Dual-comb optomechanical spectroscopy

Reviewer #1 (Remarks to the Author):

Manuscript NCOMMS-23-10200
“Dual-comb optomechanical spectroscopy”
Reply to Reviewers’ Comments:

Fig. R1 Transmission spectra of the resonant cavity. The spectra are measured with a commercial infrared spectrometer (spotlight400, PerkinElmer; resolution of 1 cm^{-1}).

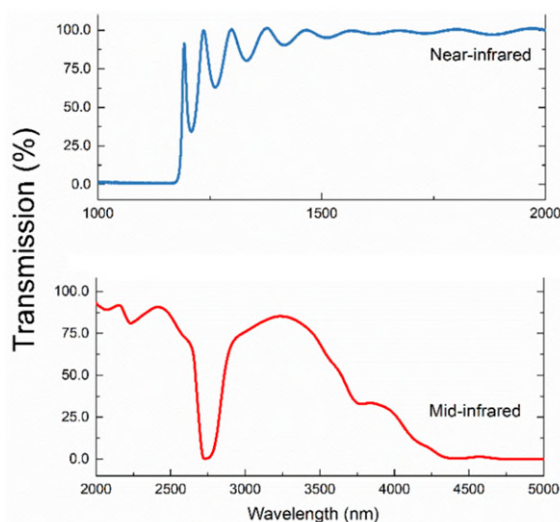
We also agree with the Reviewer that *“In this approach, the cavity needs to be resonant for the probe laser, but not for the comb. A discussion about the limitation to this approach is needed, considering mirror coatings or the choice of probe and comb laser wavelengths.”*

We measured the spectral transmittance of the mirror-in-the-middle (MIM) cavity, as shown in Fig. R1. The spectrum spans from 1200 nm to 4500 nm. The cavity is designed to be resonant with the probe laser at 1064 nm, which explains the cutoff at 1200 nm. Currently, the cavity mirrors are not for mid-infrared wavelengths above 4500 nm.

We added the figures (Figs. R1 and R2) as **Supplementary Figs. 4 and 5** and a description in the revised supplementary materials (see **Supplementary Note 4**).

Fig. R3 Picture of the MIM system.

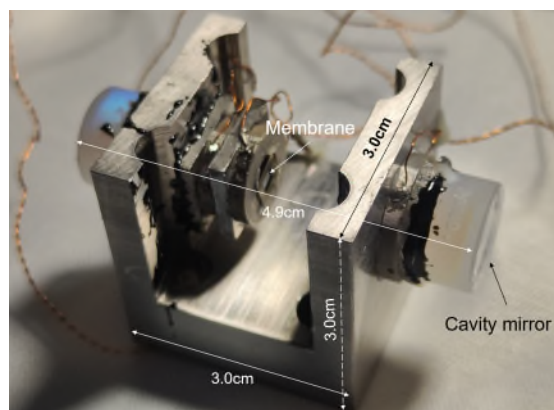
Compactness is a subjective criterion, but if the authors want to claim that their system is particularly compact, they should discuss the physical size of the device or show a photograph. Considering the simplicity of the approach, the authors point out that the cavity does not need to be resonant for the comb; however, a cavity with PDH locking is needed for the MIM system.

The Reviewer suggested us to add a picture of our MIM system (the gas sensor) in the revised supplementary materials **Supplementary Fig. 7**. The picture is also shown in the following. The size is $3 \times 3 \times 4.9 \text{ cm}^3$. Since our system does not need a long interaction length between the light and molecules, the size of our sample cell can be relatively small.

Fig. R4 Spectral measurements for the $(\nu_1+\nu_3)$ band P(17) line of $^{12}\text{C}_2\text{H}_2$ (a) at pressure of 10^3 Pa and (b) under atmospheric pressure.

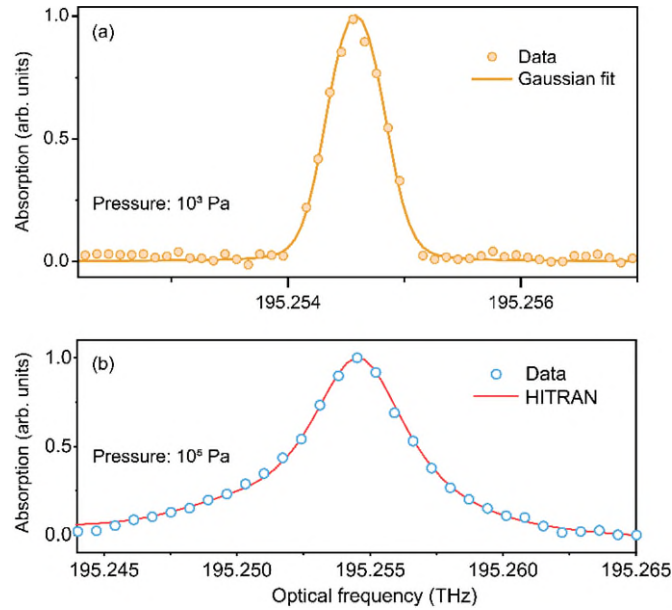
The authors should discuss the limitation on the sample pressure; does the sensor operate only at atmospheric pressure? If yes, this will limit the applicability of this approach for multispecies detection because of spectral overlap of lines of different species.

“We also measure Doppler-limited high-resolution spectra under gas pressure of 10^3 Pa with $f_r^{(1)}=100 \text{ MHz}$ (see Supplementary Note 3). Note that, like any photoacoustic sensor¹²⁻²⁰, our system detects pressure waves, the strength of which decreases with reduced gas pressure.” (p. 13, lines 16-19; original line 229)

We measured molecular spectra at 10^3 Pa with our setup for the $(\nu_1+\nu_3)$ band P(17) line of 50% $^{12}\text{C}_2\text{H}_2$. The results in Fig. R4 (a) measured within 2 s are shown in the following. The dual-comb line spacing is set to 100 MHz for measuring the Doppler-limited linewidth. The data shows a linewidth of 520 MHz, close to the Doppler limit (470 MHz). The collision broadening caused by gas molecules hitting the membrane may explain the difference. The results measured under atmospheric pressure (Fig. R4(b)) are displayed for comparison.

Fig. R5 Frequency response of the closed loop.

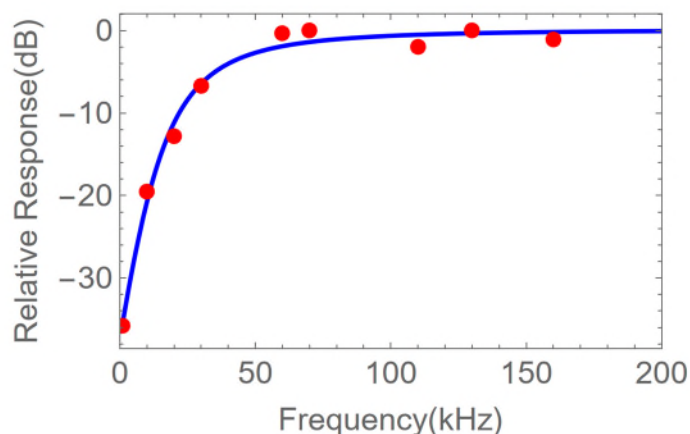
It is not clear how the signal is extracted from the PDH error signal. In closed loop, i.e. under locked conditions, at frequencies within the locking bandwidth, the error signal should be zero. Is the bandwidth of the lock much lower than 70 kHz, the frequency at which the interferograms are detected? If not, how can the signal be observed there? See more comments under NOTE 4 below.

In our experiment, the PDH error signal is feedback to the probe laser through the PZT of the laser rather than the current of the laser. Therefore, the feedback bandwidth should be much lower than 70kHz. To support this claim, we measured the closed loop's frequency response, as shown in Fig. R5. The frequency response of the closed loop is normalized with an open loop signal (with an additional probe light field which is not in resonant with the optical cavity and thus without the influence of feedback). Figure R5 shows the frequency response of PDH locking from 1 kHz to 200 kHz. The 3-dB frequency is around 45 kHz, which is much lower than 70 kHz. Therefore, the signal at $\sim 70\text{kHz}$ is barely influenced by the PDH feedback loop.

Fig. R6 The updated Fig. 4b in the revised manuscript.

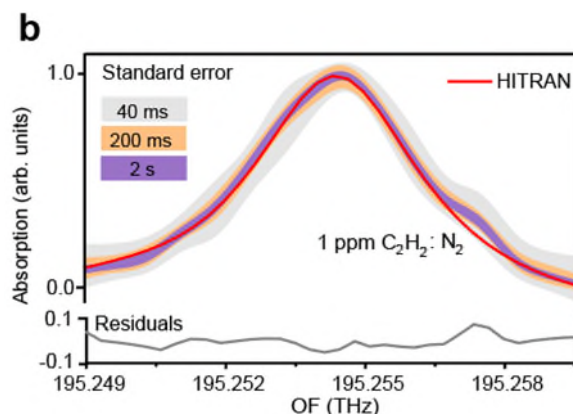
18. Fig. 4b: *There are visible systematic discrepancies between the HITRAN model and the data. Plot the residuals and discuss the cause of the discrepancies.*

We plotted the residuals in the revised version, as shown in the following. We also updated Fig. 4b in the revised manuscript.

The discrepancies are within $\pm 8\%$ between the 2-s data and the HITRAN simulation. The discrepancies are caused by the additional electronic amplifier we used for amplifying the small PA signal in the low-concentration measurement. The amplifier may distort weak components at the edges. Since the discrepancies are relatively small, they do not significantly influence concentration measurements. For high-concentration measurements (see Fig. R4(b)), we did not notice the discrepancies around 195.258 THz.
